**Economic Commission for Europe****Inland Transport Committee****World Forum for Harmonization of Vehicle Regulations****Working Party on Lighting and Light-Signalling****Seventy-eighth session**

**Other Regulations:****Regulation No. 10 (Electromagnetic compatibility)****Proposal for Supplement 2 to the 05 series of amendments to Regulation No. 10 (Electromagnetic compatibility)****Submitted by the Task Force on Electromagnetic Compatibility (TF EMC)\***

*Appendix 4,*

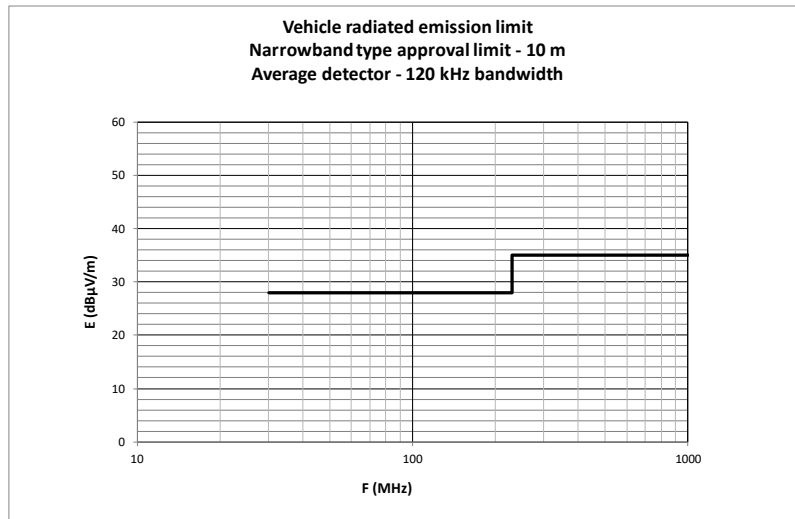
Figure, amend to read:

Frequency - megahertz - logarithmic  
(See paragraph 6.3.2.1. of this Regulation)”

| <i>Limit E (dB<math>\mu</math>V/m) at frequency F (MHz)</i> |                      |
| <b>30-230 MHz</b>   | <b>230-1,000 MHz</b> |
| <b>E = 28</b>   | <b>E = 35</b>        |

Appendix 5,

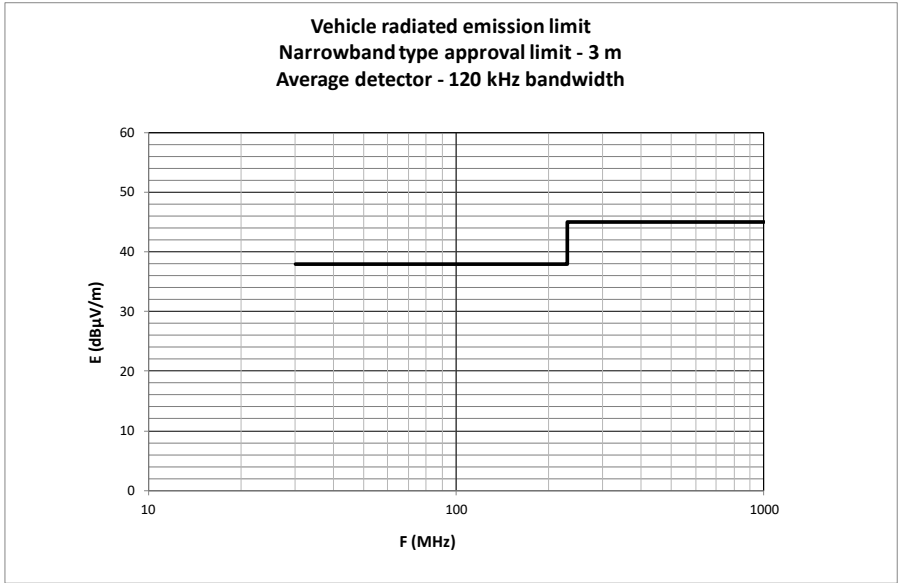
Figure, amend to read:

Frequency - megahertz - logarithmic  
 (See paragraph 6.3.2.2. of this Regulation)”

| <i>Limit E (dB<math>\mu</math>V/m) at frequency F (MHz)</i> |                      |
| <b>30-230 MHz</b>   | <b>230-1,000 MHz</b> |
| <b>E = 38</b>   | <b>E = 45</b>        |

## “Appendix 8

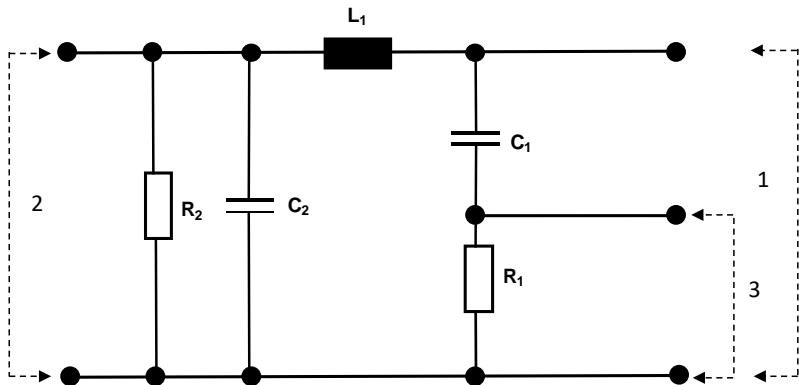
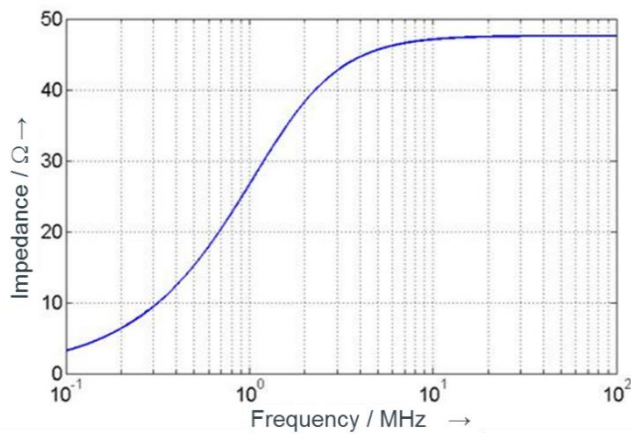
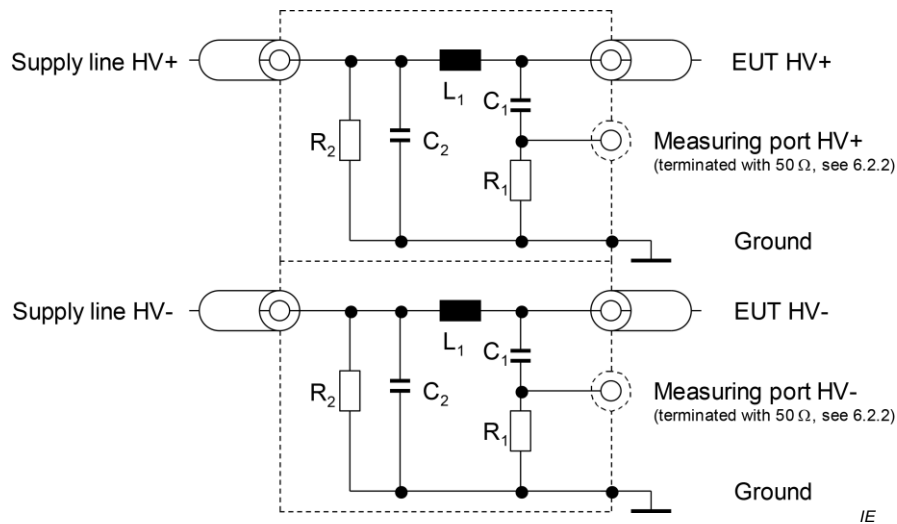
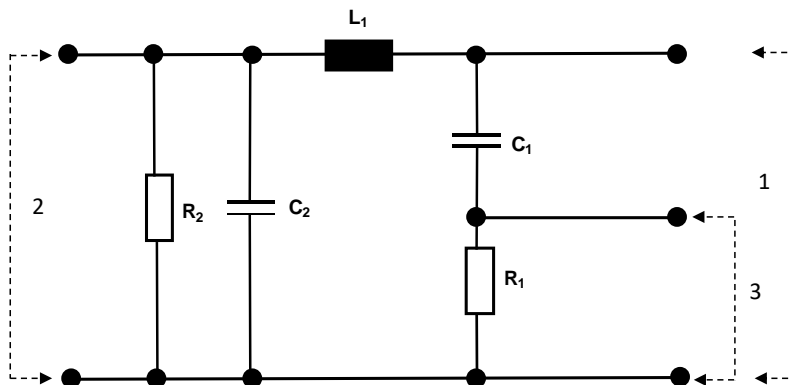
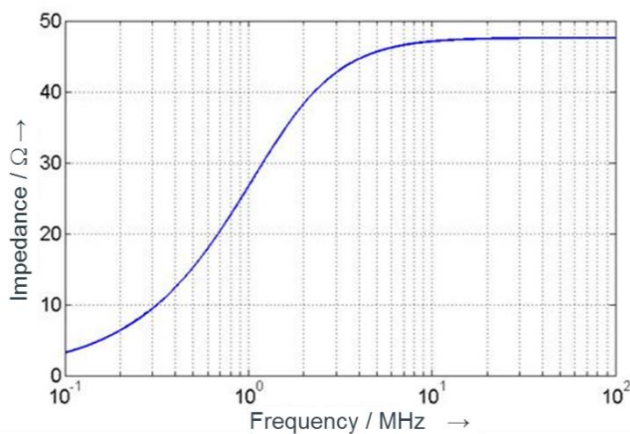
Appendix 8, amend to read:

If unshielded HV ANs are used in a single shielded box, then there shall be an inner shield between the HV ANs as described in 3.

**Figure 3**  
**Vehicle in configuration "REESS charging mode" coupled to the power grid:**  
**Example of test set-up for vehicle with plug located on vehicle side (AC powered without communication)**

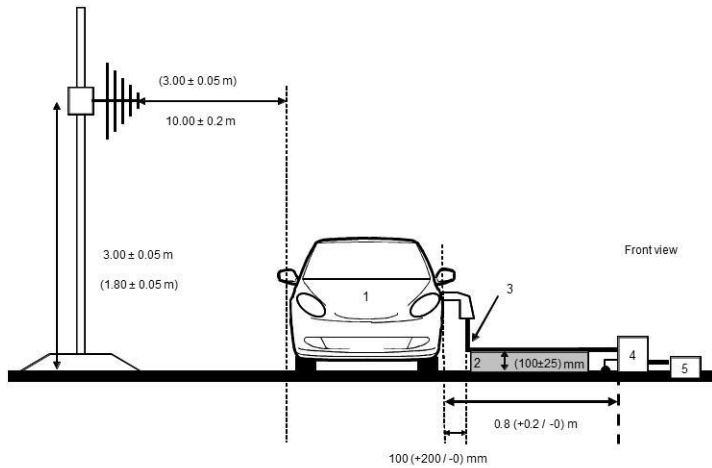
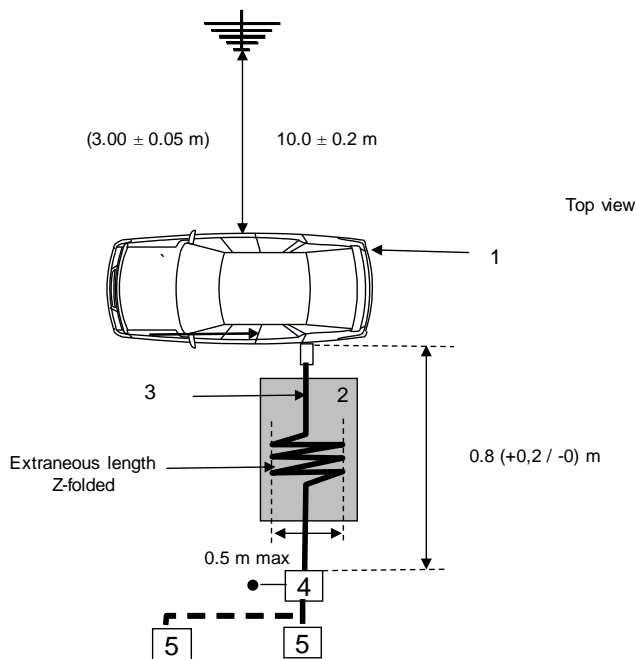
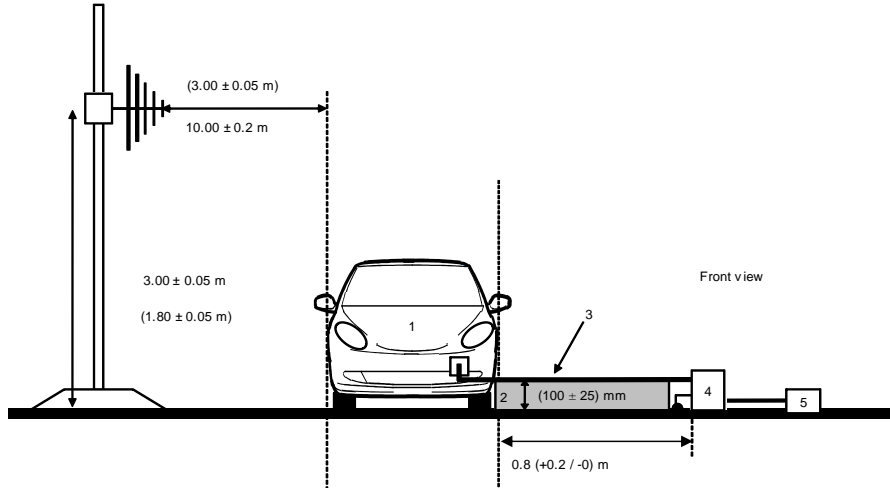
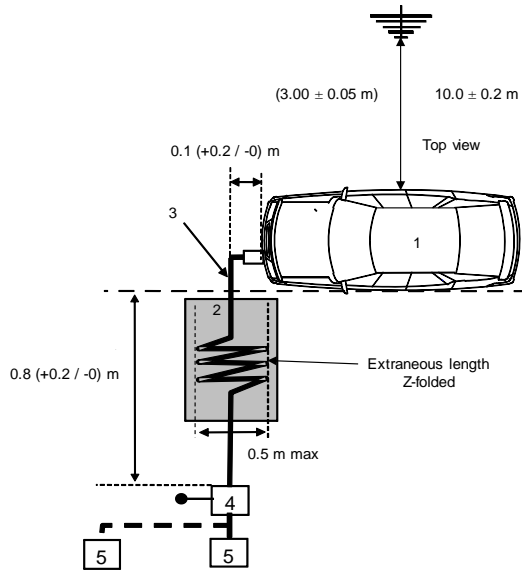
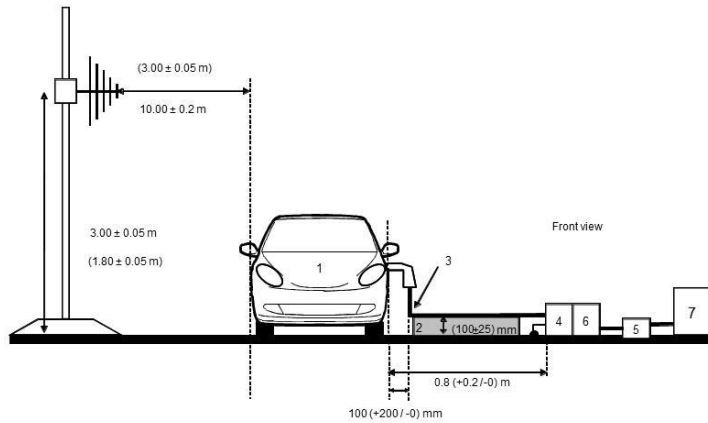
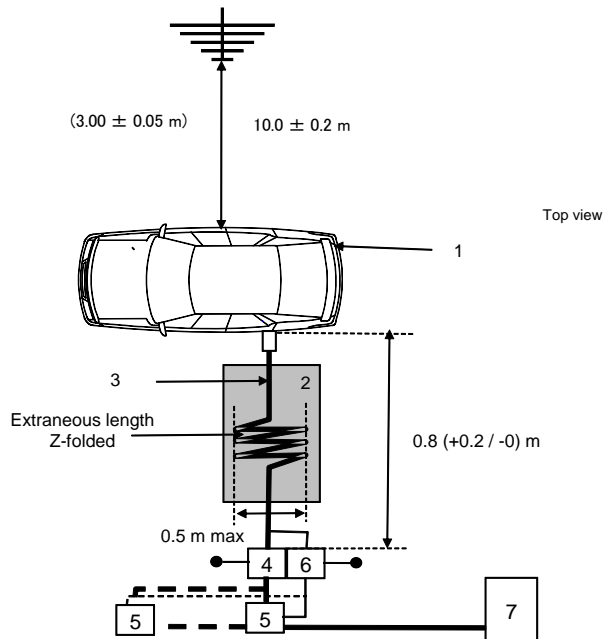
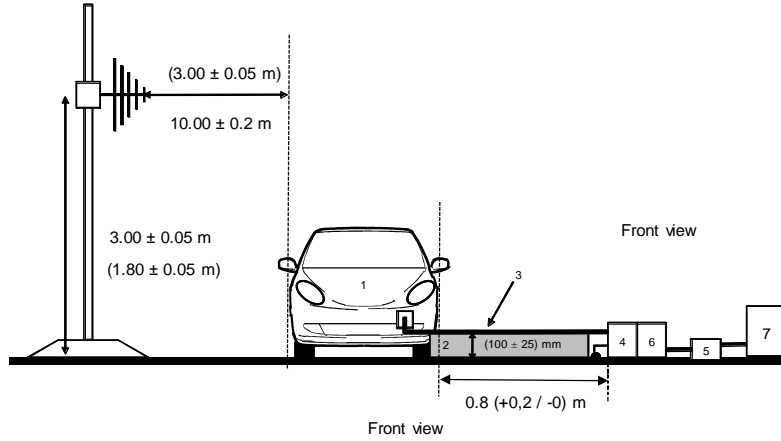
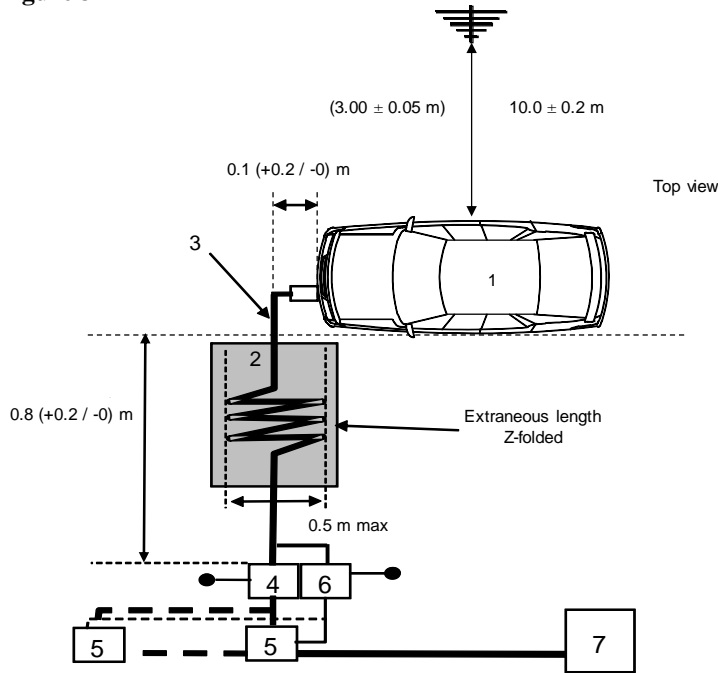
Appendix 1, amend to read:

**Figure 4**

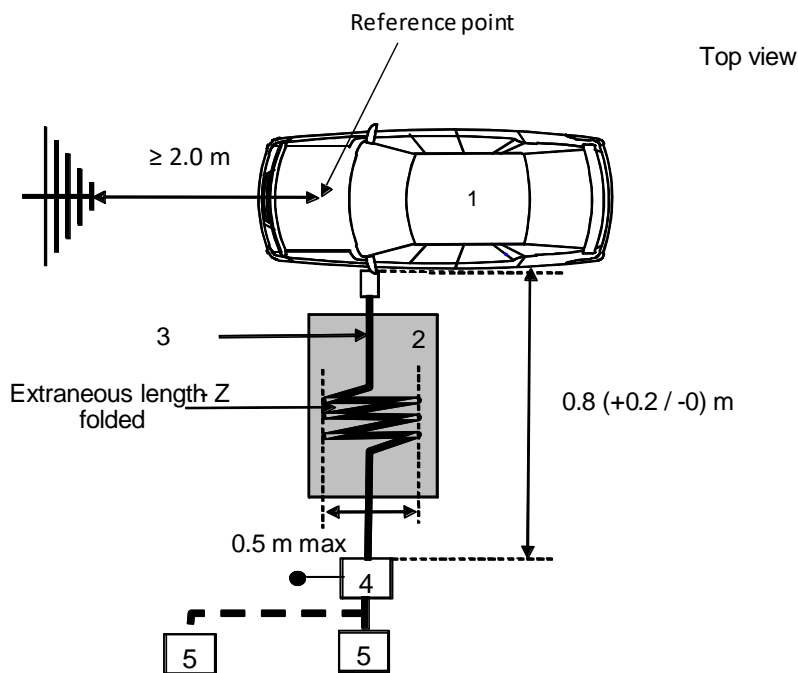
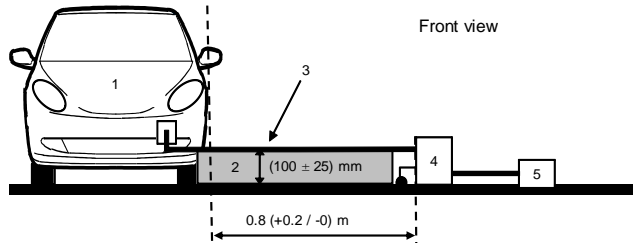
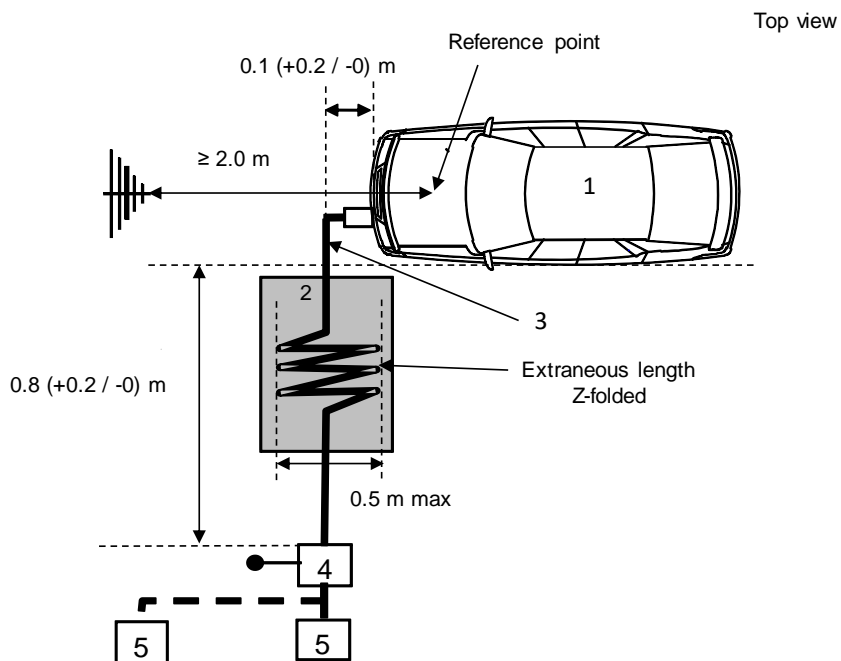
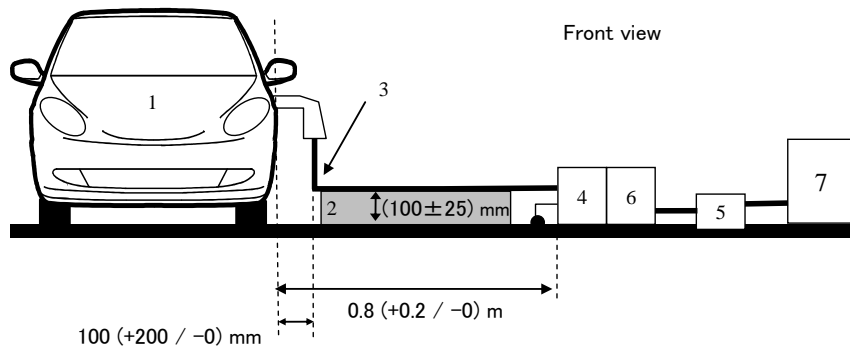
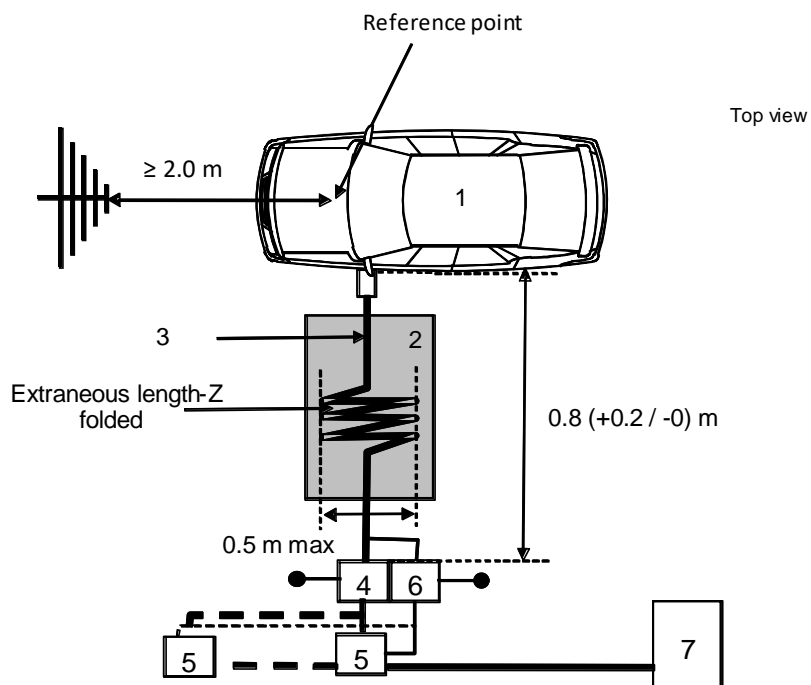
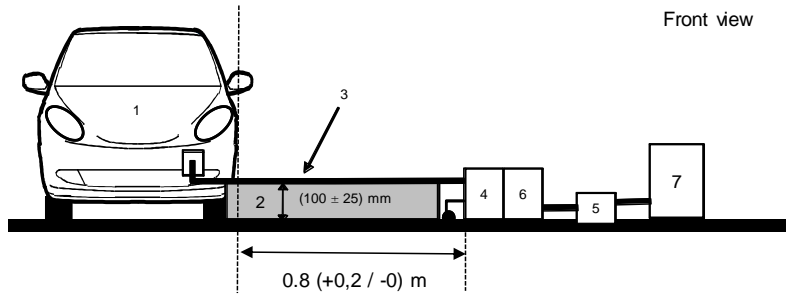
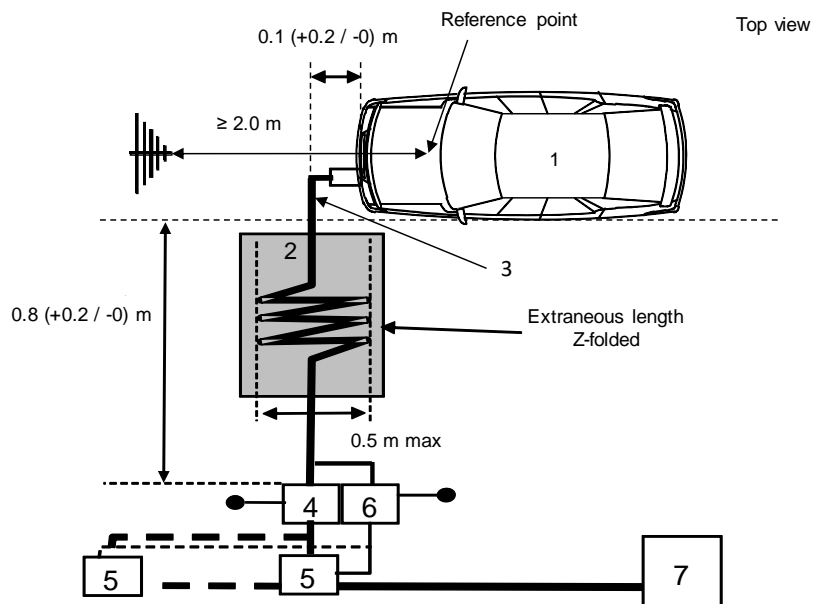
*Appendix 1, amend to read:*

Figure 1

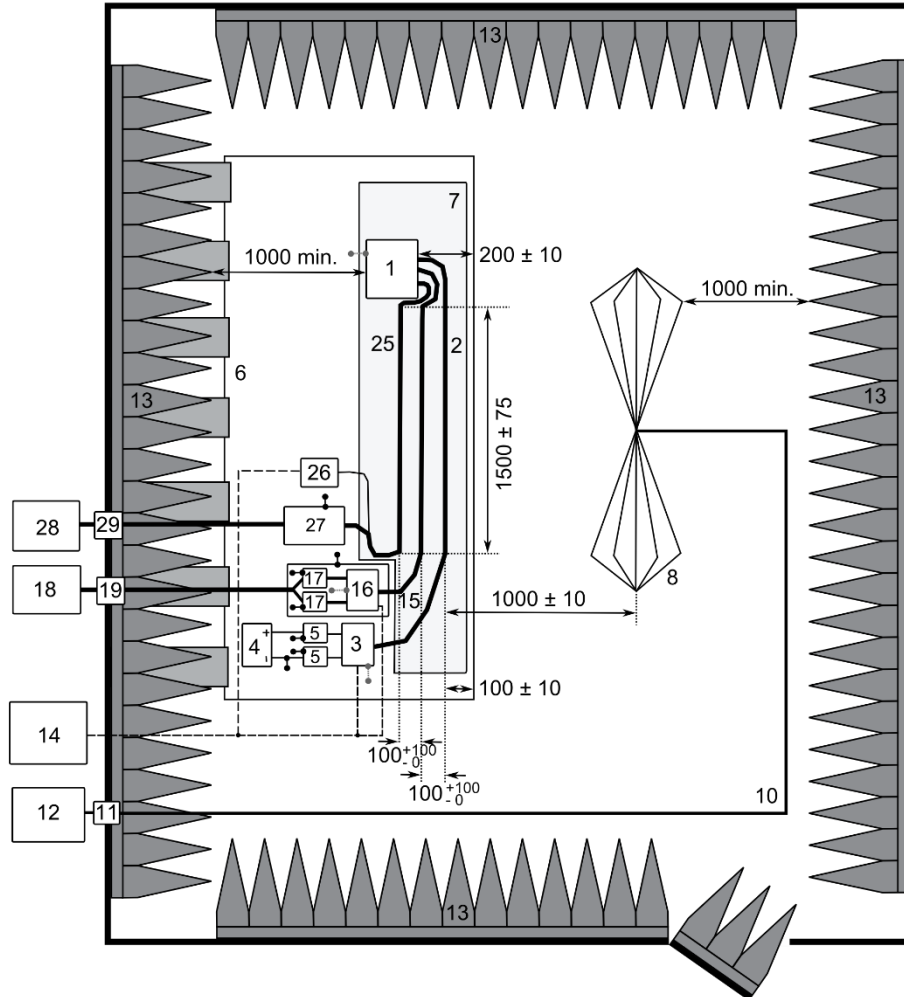
Annex 7, Appendix, delete and replace by:

**Figure 1**  
**ESA in configuration "REESS charging mode coupled to the power grid" (floor-standing equipment)**

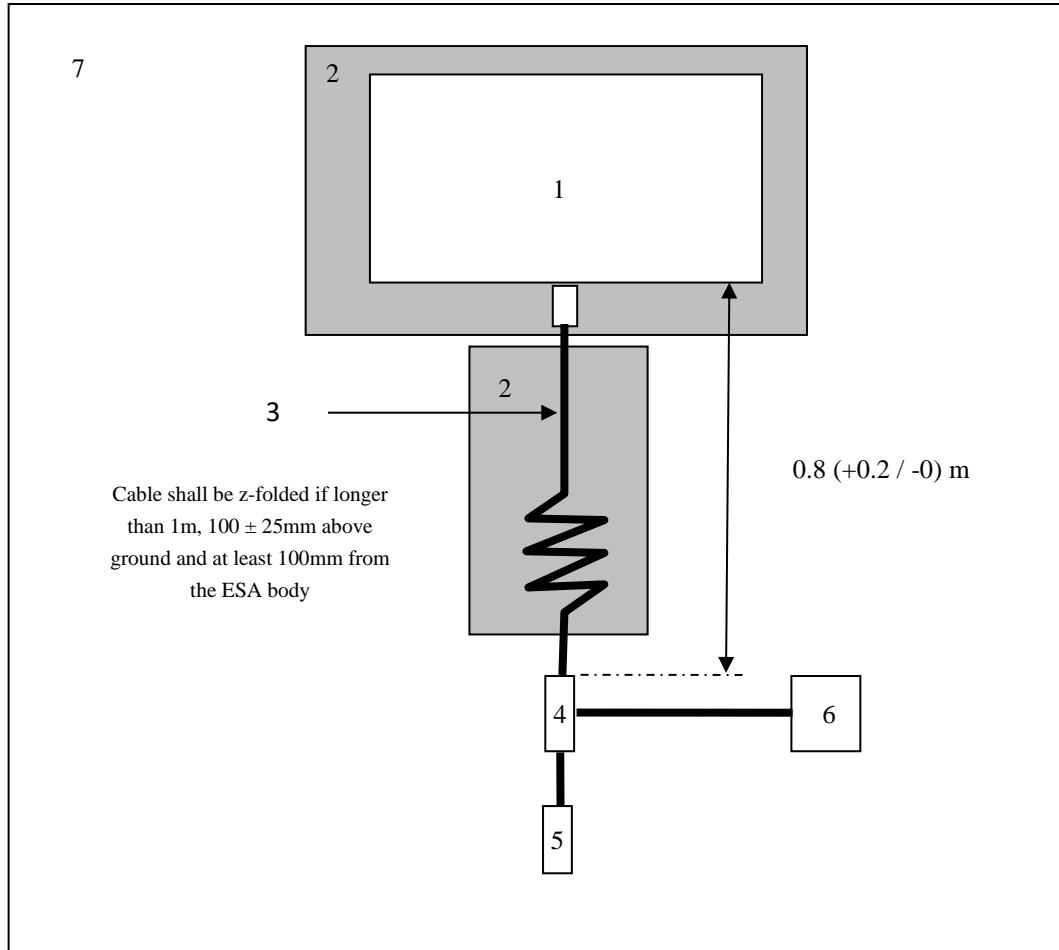
*Annex 19, Appendix 1*, amend to read:

Figure 1  
**ESA in configuration "REESS charging mode coupled to the power grid" (floor-standing equipment)**

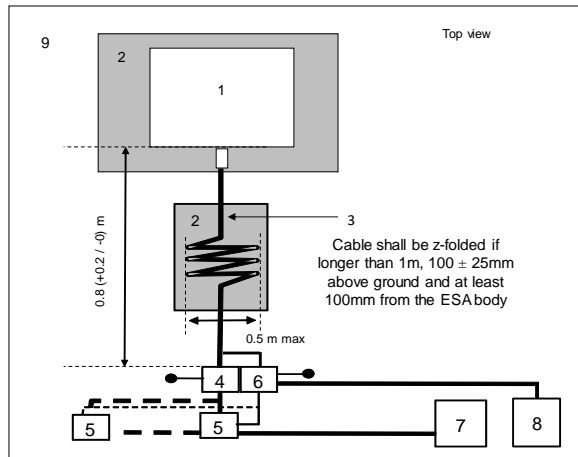
Annex 20, Appendix 1, delete and replace by:
